NUMBER: 08-007-17 REV. H
GROUP: 08 - Electrical
DATE: November 29, 2017

THIS BULLETIN SUPERSEDES SERVICE BULLETIN 08-007-17 REV. G, DATED SEPTEMBER 14, 2017 . WHICH SHOULD BE REMOVED FROM YOUR FILES. ALL REVISIONS ARE HIGHLIGHTED WITH **ASTERISKS**** AND INCLUDE ADDITIONAL SYMPTOM/CONDITION AND ADDITION OF STEP #9 WITH ILLUSTRATIONS IN REPAIR PROCEDURE.**

UAS, UCQ, UDQ, UJQ and UAQ Radio Enhancements

2017	(LA)	Dodge Challenger
2017	(LD)	Dodge Charger
2017	(LX)	Chrysler 300

Fig. 6
Navigation Radio Files

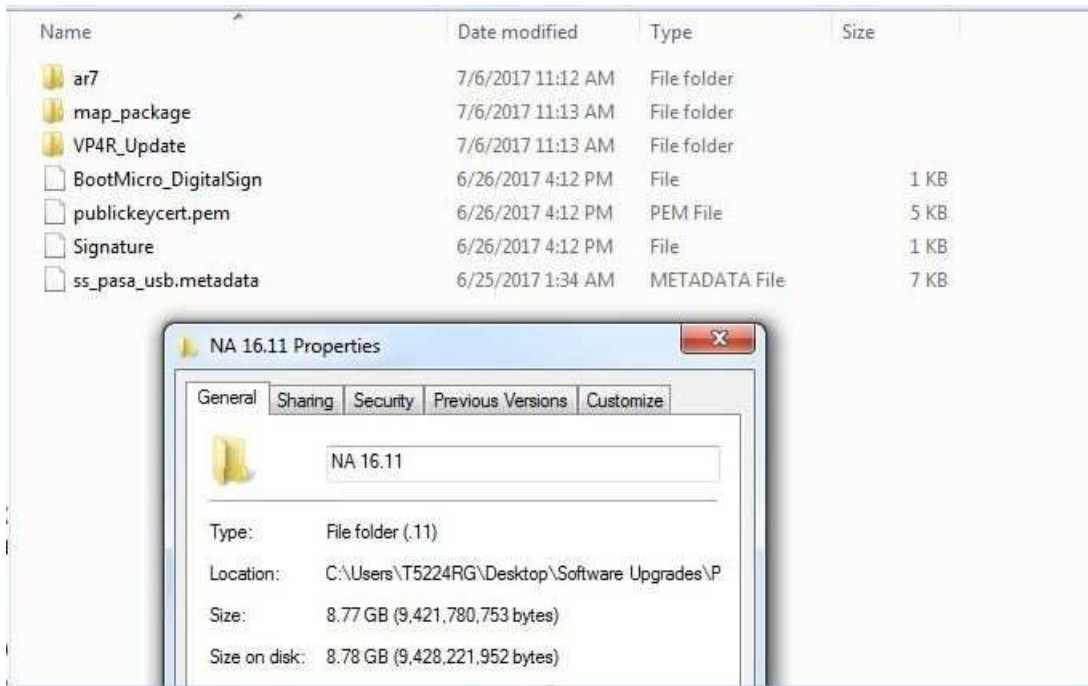
9. **Verify the content on the flash drive matches (Fig. 6) for Navigation equipped radios and (Fig. 7) for Non-Navigation equipped radios.**
